Re: Approval of Mining Underneath Box Canyon in the 3<sup>rd</sup> and 4<sup>th</sup> Left Panels, Minor Modification to the Resource Recovery and Protection Plan (R2P2), Federal Coal Lease UTU-76195

### Documentation of Land Use Plan Conformance and NEPA Adequacy (DNA)

**Proposed Action Title/Type:** Minor Modification to an approved Resource Recovery and Protection Plan to fully extract coal underneath a 143.25 acre portion of the East Fork of Box Canyon Creek Drainage.

**Figure 1 MSO 2002 and 2003 Survey Area**

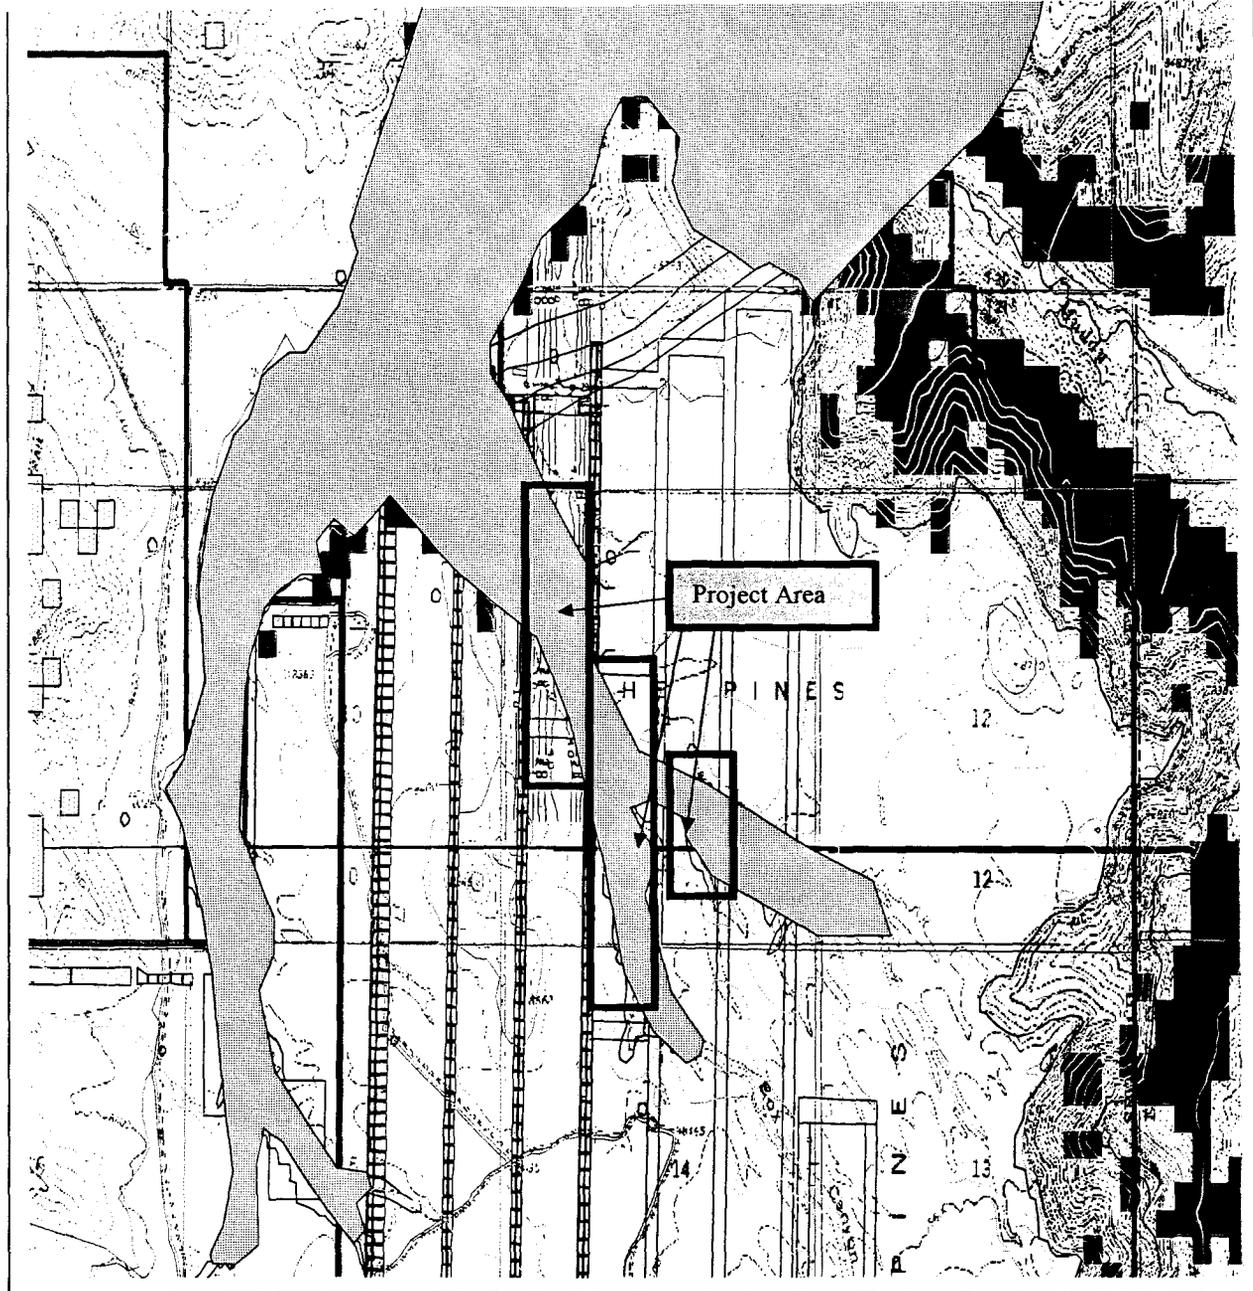
Subsequent to the FEIS, part of the project area, including portions of the East Fork of Box Canyon, were identified as possible habitat for the Mexican spotted owl

Impacts to raptors including Bald Eagle, Northern Goshawk, Peregrine Falcon, and the Flammulated Owl were analyzed in the FEIS for the Pines Tract Project. The FEIS determined that an impact to the surface hydrology which might reduce the riparian area, could, reduce foraging habitat for these species. Escarpment issues were discussed in the FEIS. The Recovery plan for the MSO states that "owls occur primarily in steep-walled, rocky canyons". The FEIS (p 3-17) states, "These combined factors [convex-shaped, shallower canyon and exposure] suggest that cliffs in Box Canyon and the East Fork of Box Canyon [interior cliffs] should be less susceptible to mining-induced instability compared with the observations made during test mining in Quitchupah Canyon [exterior cliffs]". Underground mining has occurred under the ephemeral portion of the Main Fork of Box Canyon. There were approximately 3 escarpment failures in the entire area covering approximately 6000 linear feet of escarpment. This equates to approximately 3% of the linear cliff face that was affected. Therefore the statements in the FEIS are substantiated because of the small amount of cliff failure that would be encountered. Even if owls are present, the probability of an owl nest being affected by subsidence would be minimal.
